Technical Service Bulletin: TSB110150

Hydraulic Pump Drives and Adapters

Hydraulic Pump Front and Rear View

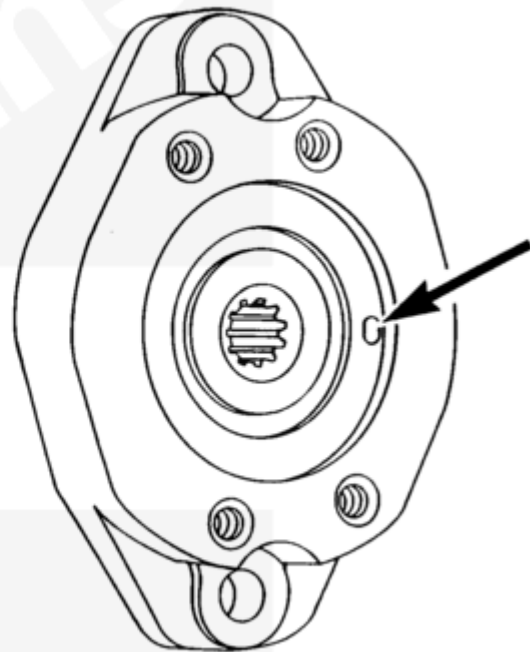
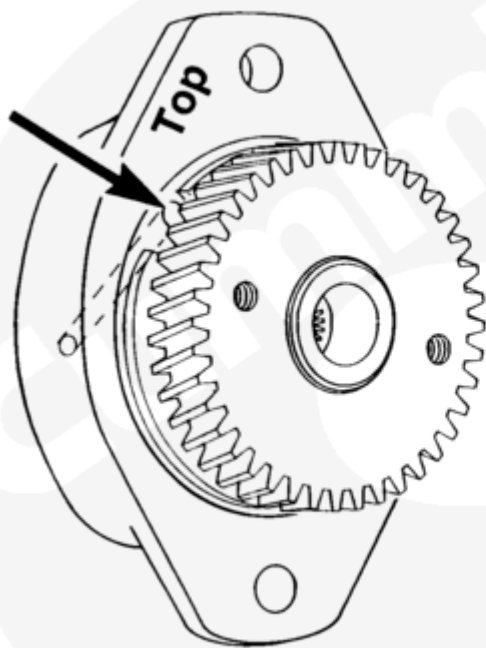
This document introduces a new hydraulic pump adapter for hydraulic pump drive options in applications where an air compressor is **not** used. The new adapter was introduced on January 20, 1993 at CDC. Engine Serial Number first 44828852. The new adapter includes a drilling that transfers lubricating oil from the gear housing to the hydraulic pump drive connection to the hydraulic pump spline shaft to reduce wear on the spline drive teeth. Failure of lubricating oil reaching this connection could result in spline shaft or spline drive failure.

Install by orientating the adapter so that the oil collection hole is on the top side of the accessory gear. The word "TOP" is printed on the face of the adapter and should be positioned so that it is on the top end of the adapter when installing. Failure to install properly will **not** allow lubricating oil to reach the spline shaft connection. See page 2 for a list of new part numbers which have the lubricating oil collection hole improvement.
